# **AQUIND INTERCONNECTOR**

## Design and Access Statement

Document Ref: 5.5

**DATE: 14 NOVEMBER 2019**

**Plate 4.1- Green panels and curved roofs**

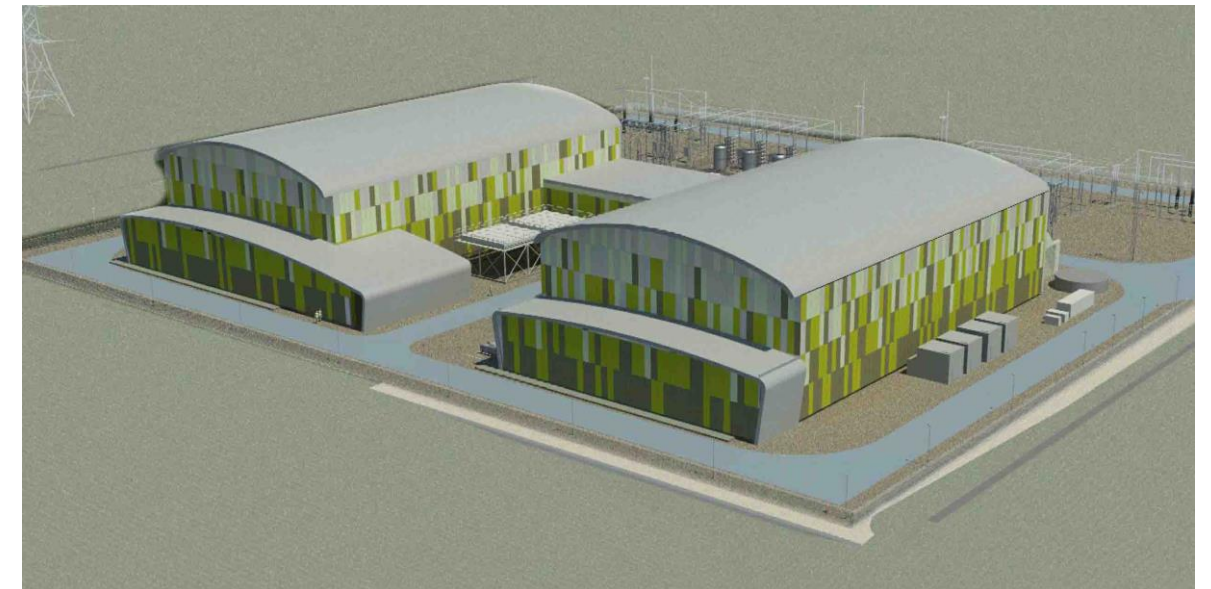
4.3.2.4. A number of questions and comments were received, notably:

- **Comment:** (WCC) Why are vertical rather than horizontal bands being used?
- **Response:** Vertical bands were selected as Architects had worked on buildings of similar scale. EHDC commented that they had seen the successful application on a number of projects with vertical bands.

- **Comment:** (WCC) Should the size of band widths be wider to reflect an “honesty” in the size of a large scale building?
- **Response:** Band widths could be varied and looked at, in option development.

- **Comment:** (WCC) Could timber be used to replicate some of the barns within the vicinity?
- **Response:** Due to operational requirements wooden materials are not acceptable within a live converter station site.

- **Comment:** Should the building be concealed or celebrated?
- **Response:** This was a concept that was proposed by EHDC, but other attendees expressed a preference for concealment. The alternatives were debated and it was agreed that prominent curved roofs (Plate 4.1) would be discounted.

**Plate 4.3 – Vertically arranged green cladding**

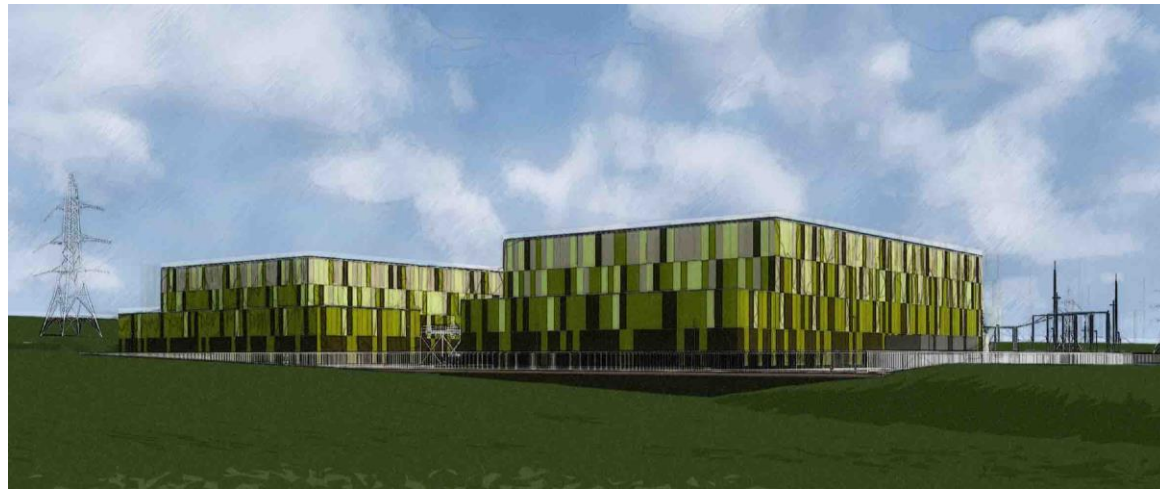
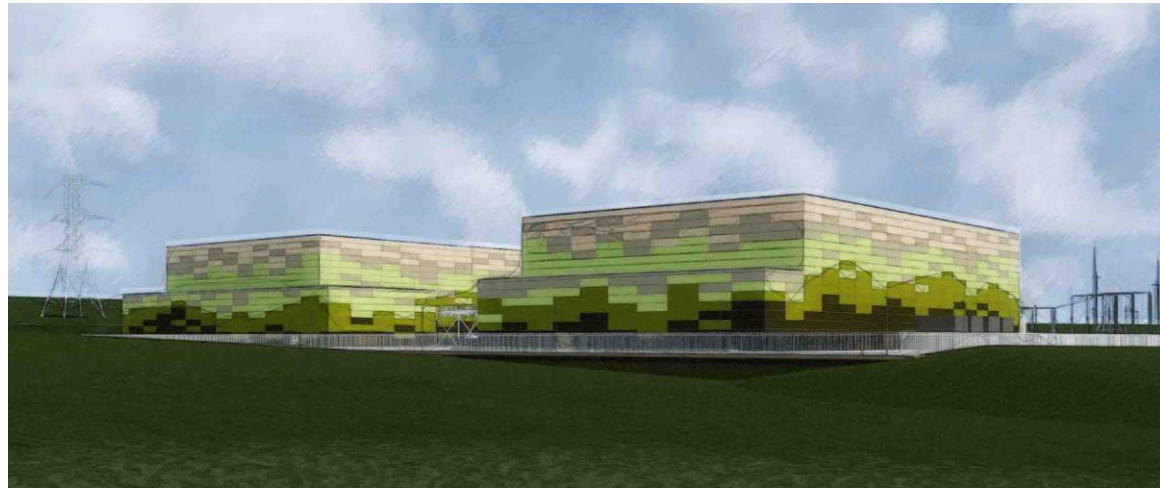
- **Comment:** (WCC) The concept of “hiding” the building or “celebrating” it was discussed again.
- **Response:** There was no strong preference either way from the attendees. It was agreed that the differing concepts would be considered as the indicative designs progressed.

- **Comment:** (WCC) Request to consider using cut and fill to lower the overall height of the building further
- **Response:** It was noted that the site sits above an aquifer that would restrict the extent of excavations but it was the projects intention to conduct a cut and fill assessment exercise.

- **Comment:** (SDNPA) Type and nature of roofing materials queried.
- **Response:** It was confirmed at the meeting that neutral, matt, mid-range colours for roof cladding would be considered

- **Comment:** (WCC) Preference for darker, less reflective colours
- **Response:** Taken on board in selection of colour palette
- **Comment:** (WCC, EHDC and SDNPA): Concerns raised regarding delivery of final design within the DCO process.

- **Response:** Agreed that a set of Design Principles and Parameters will be developed for inclusion in the DCO. (Refer to section 6) These would be the mechanism that would control the final design.

**Plate 4.10 – Contextual colour studies**

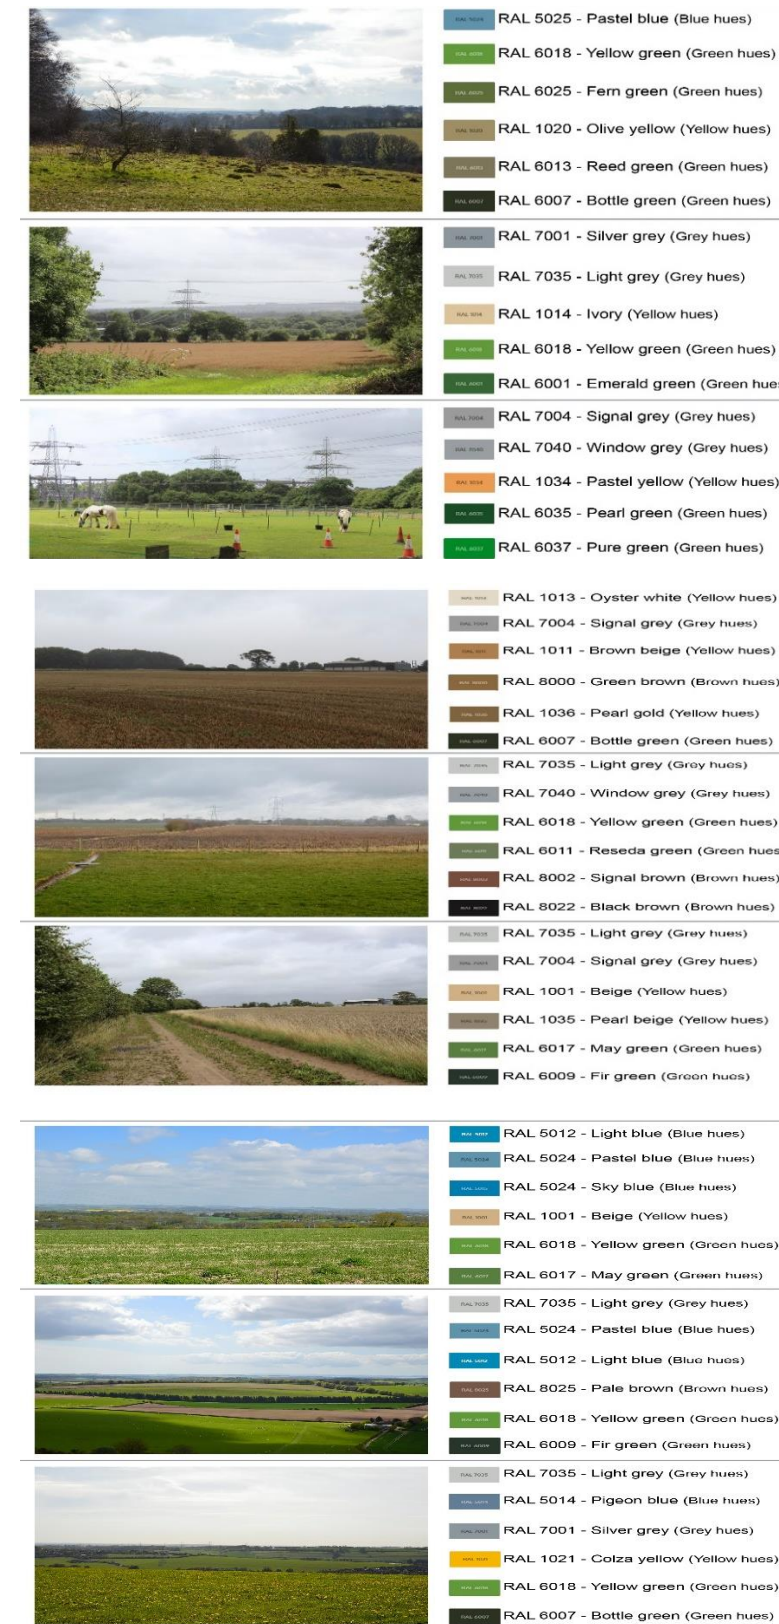
- **Comment:** (EHDC) Further development of contextual colour studies presented requested (refer to Plate 4.10 for studies presented). Variation and gradation of colours to different elevations considered.

- **Response:** Defined colour palettes will be developed from the contextual studies. Variation and gradation of colours to different elevations to be considered.

**Plate 4.11– “Summer Greens” option.**

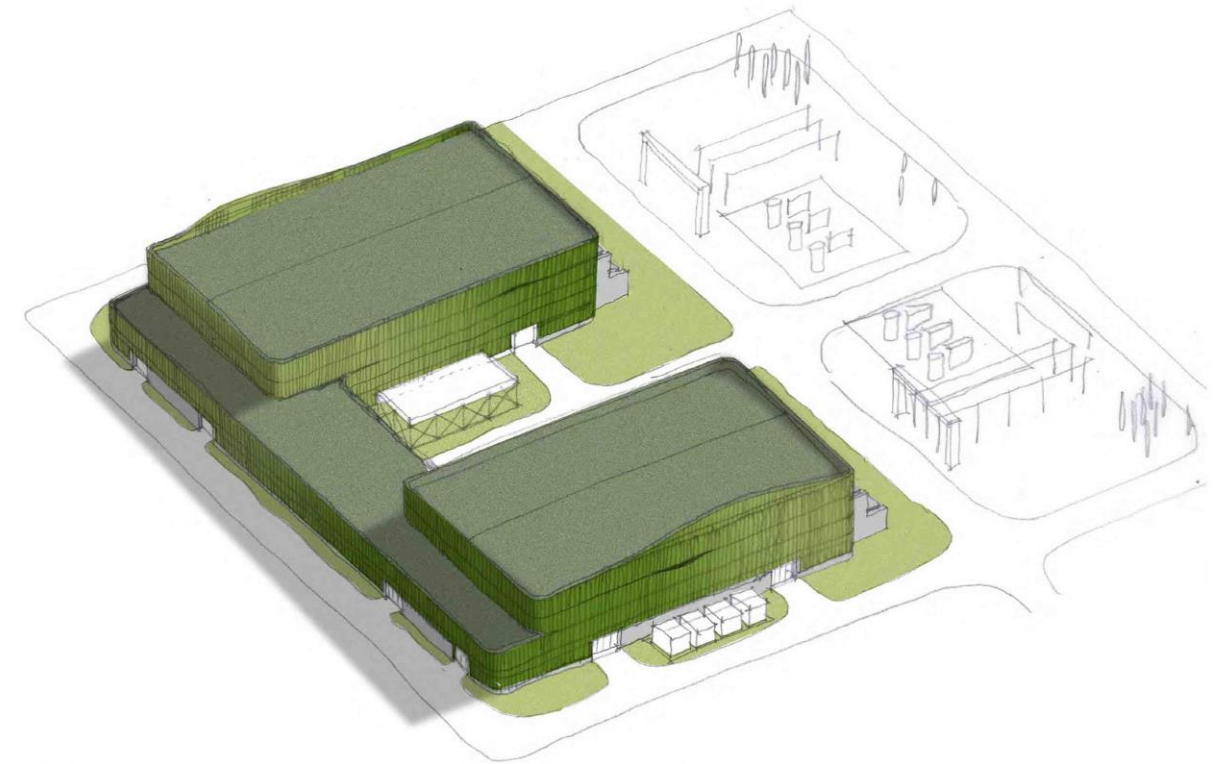
- **Comment:** (WCC) Request to explore a distinctive plinth element
- **Response:** It was agreed to consider in further detailed design development
- **Comment:** (WCC and SDNPA) Agreement to discount the “summer greens” colour palette (refer to Plate 4.11)

- **Response:** Agreed to be discounted from illustrative designs.
- **Comment:** (WCC and SDNPA) Agreement that darker colours rather than lighter would be preferable.
